# CITY OF HAYWARD AGENDA REPORT

Site Plan Review No. PL-2005-0525 & Tentative Tract Map No. 7699/PL-

2005-0527 - Jitender Makkar, Edge Concepts Inc. (Applicant/Owner) - Request to

Subdivide a Half-Acre Parcel and Develop Five Townhomes

Date	Drawing Number
11-18-05	
Scale	
AS NOTED	TM-1
Project Number	
05-295	SHEET 1 OF 1

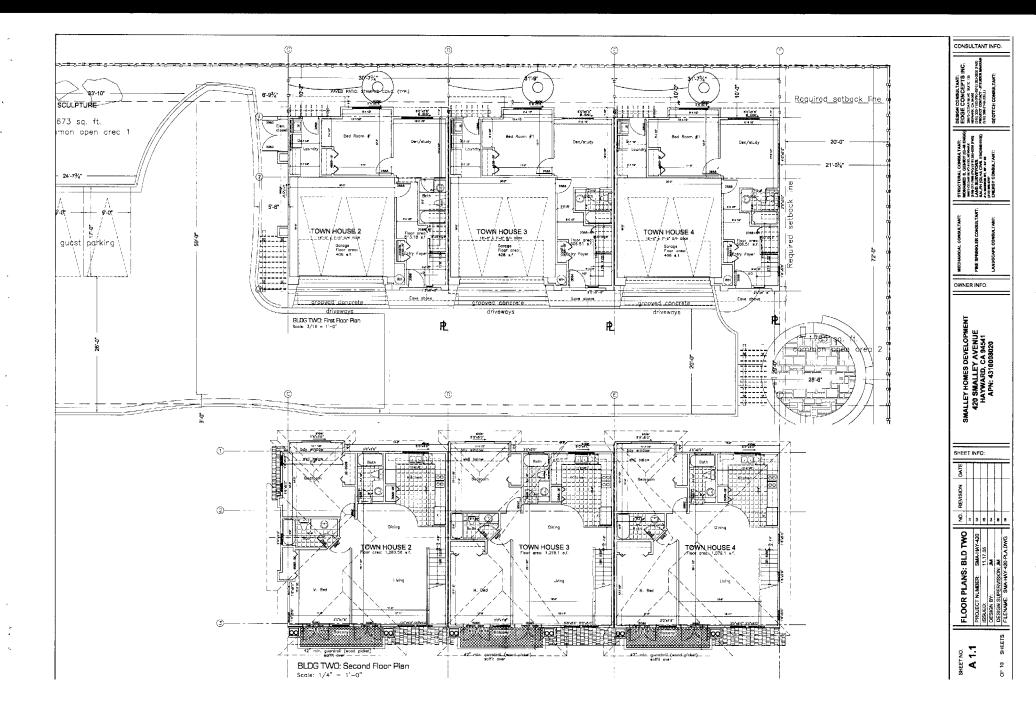
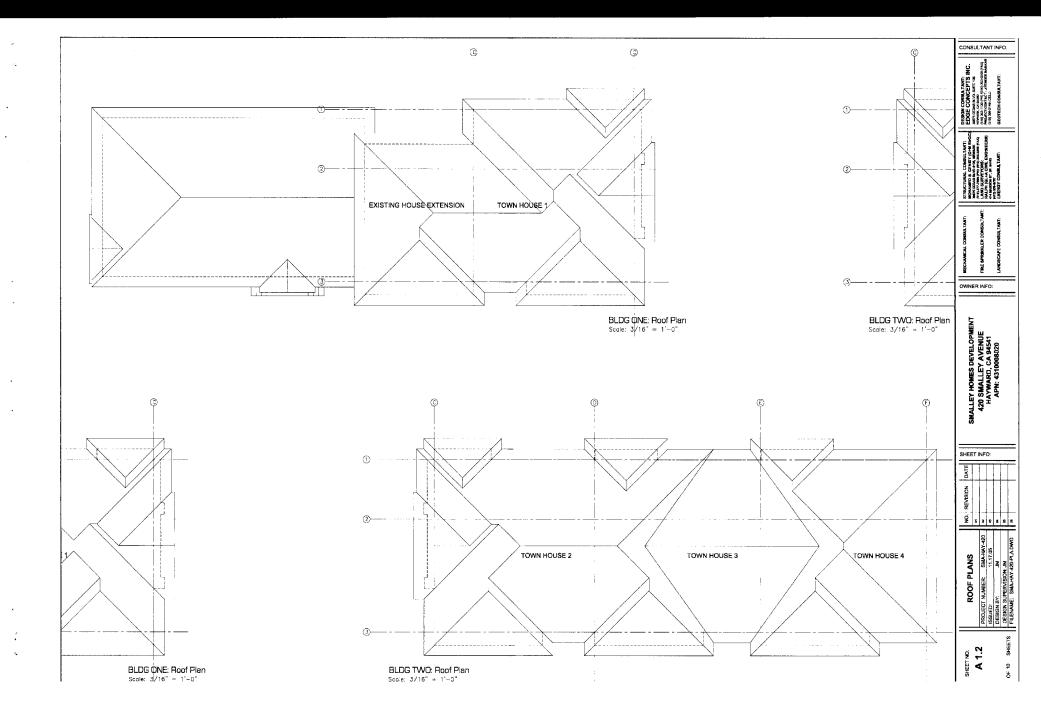
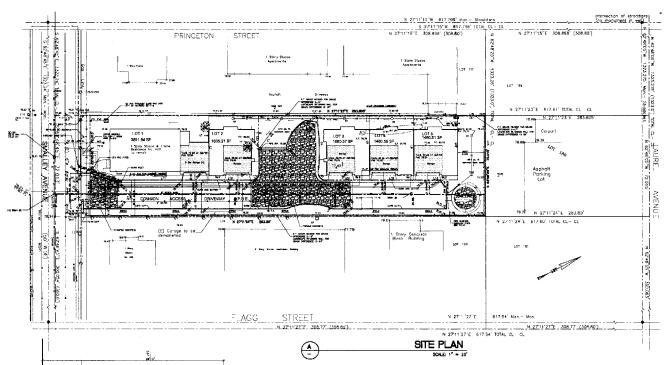
- 24. Water service is available subject to standard conditions and fees in effect at the time of application.
- 25. The looped water main shown is not acceptable. The water services for the townhouses shall be served by a service manifold to be located in the Smalley Ave. ROW. The service manifold shall be located 6 feet from sanitary sewer laterals.
- 26. Each residential unit shall have an individual radio read water meter.

- 29. Fire Department requirements shall be as follows:
  - a. The private driveway is shown on the plan with a 20-foot roadway width. This driveway shall be posted as a fire lane and no parking of vehicles shall be allowed on either side. Red curbing will be required for the entire length of the driveway. Signs shall be posted to allow towing of illegally parked vehicles to ensure adequate fire truck access.

35. A perimeter retaining wall with a 6 foot fence on top, is shown on the plans. The developer shall work with the adjacent property owners to have one fence along the property line, rather than two fences back to back. The design and location of this wall/fence will need to be reviewed and approved by the Planning Director and City Engineer. A separate building permit will be required for this structure.
